### STAFF RECOMMENDATION 1611 Fatherland Ave May 17, 2017

**Application:** New construction – outbuilding and Setback determination  
**District:** Lockeland Springs-East End Neighborhood Conservation Zoning Overlay  
**Council District:** 06  
**Map and Parcel Number:** 19514000500  
**Applicant:** Anna & Erwin Herceg  
**Project Lead:** Jenny Warren, [jenny.warren@nashville.gov](mailto:jenny.warren@nashville.gov)

**Description of Project:** Construction of a new outbuilding with a side setback determination.

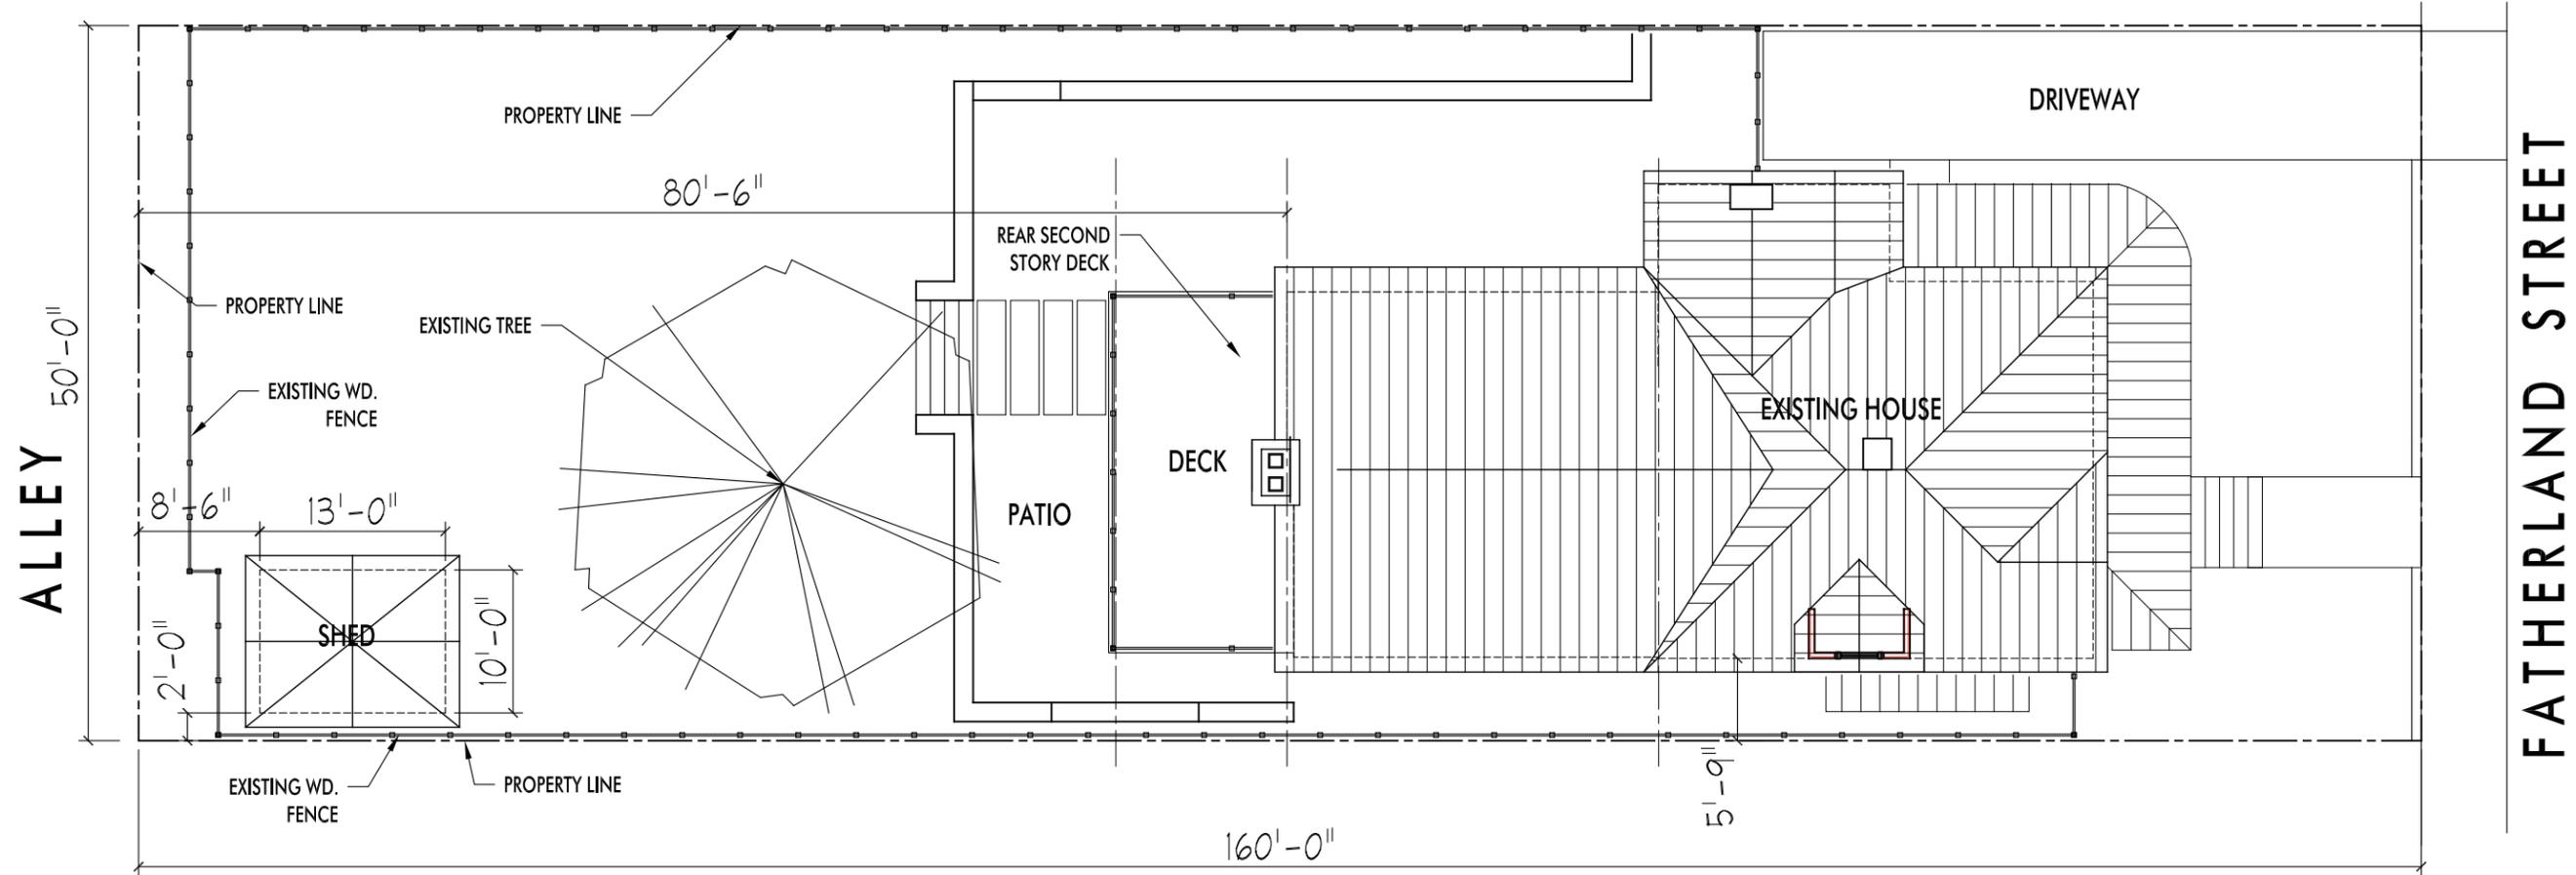
Height and scale: The eave height of the outbuilding is twelve feet (12') compared to twenty-one feet (21') on the principal structure. The ridge height is eighteen and a half feet (18.5') compared to twenty-eight feet (28') on the principal structure. The maximum allowable eave height is seventeen feet (17') and maximum ridge height is twenty-five feet (25').

On lots less than 10,000 square feet, the footprint shall not exceed seven hundred fifty square feet (750 sq. ft.). With a foot print of one hundred thirty square feet (130 sq. ft.), this outbuilding meets the guidelines. Staff finds that the outbuilding is compatible with the main structure in height and scale and meets Section II.B.8 of the design guidelines.

**Roof Shape and Materials:** The existing home has a cross-gable with hipped roof form. The outbuilding has a cross-gabled roof. The standing seam metal roof matches the roof on the main house. The roof shape and materials are compatible with the main house and meet Section II.B.8 of the design guidelines.

**Design Standards:** The outbuilding has a fairly simple design that is appropriate for outbuildings. Its roof form, detailing and overall form do not contrast greatly with the primary structure. The outbuilding is in a minimally-visible location at the side and rear

of the primary structure. Though tall, the outbuilding has a small footprint. Staff finds that the design meets section II.B.8 of the design guidelines.

■ SITE PLAN- EXISTING

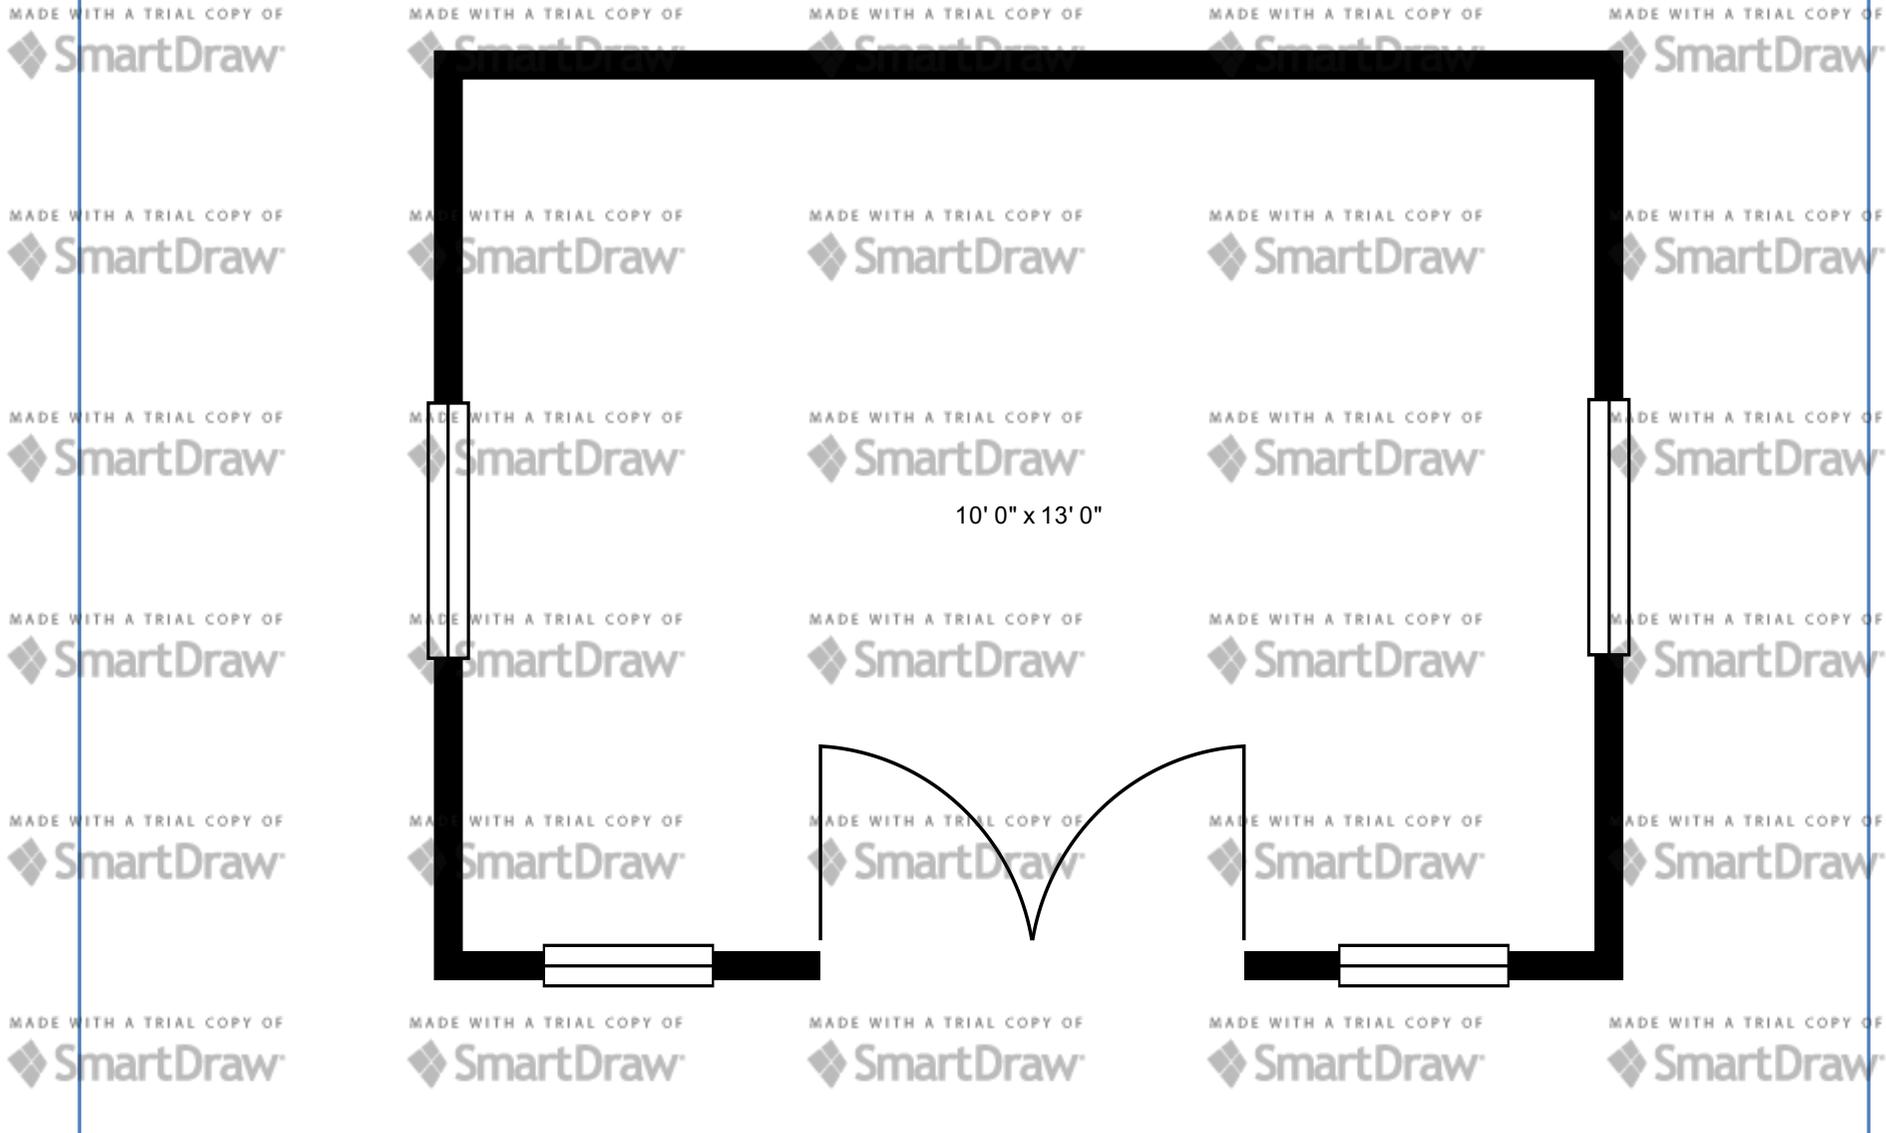
Location & Setbacks: The building is located in the rear yard, which is a typical location for historic outbuildings. The new outbuilding does require a setback determination. When an outbuilding has a footprint of less than seven hundred square feet (700 sq. ft.), base zoning requires that the structure be located three feet (3') from both the side and rear property lines, since the building does not have garage doors facing the alley. In this instance, the outbuilding is sited eight feet six inches (8'6") from the rear property line and does meet the base zoning rear setback. However, it is only located two feet (2') from the side property line, rather than the required three feet (3'). Staff finds the side setback to be appropriate because of the minimal footprint of the building, which is only thirty-square feet (30 sq. ft.) more than an outbuilding that would not require review and because historically, outbuildings were located at the rear of the property, close to the rear and side property lines.

Staff recommends approval of the outbuilding, with the two foot (2') side setback and with the condition that staff approve the texture of stucco prior to installation. With this condition, Staff finds that the outbuilding meets section II.B.8 of the *Lockeland Springs-East End Neighborhood Conservation Zoning Overlay: Handbook and Design Guidelines*.
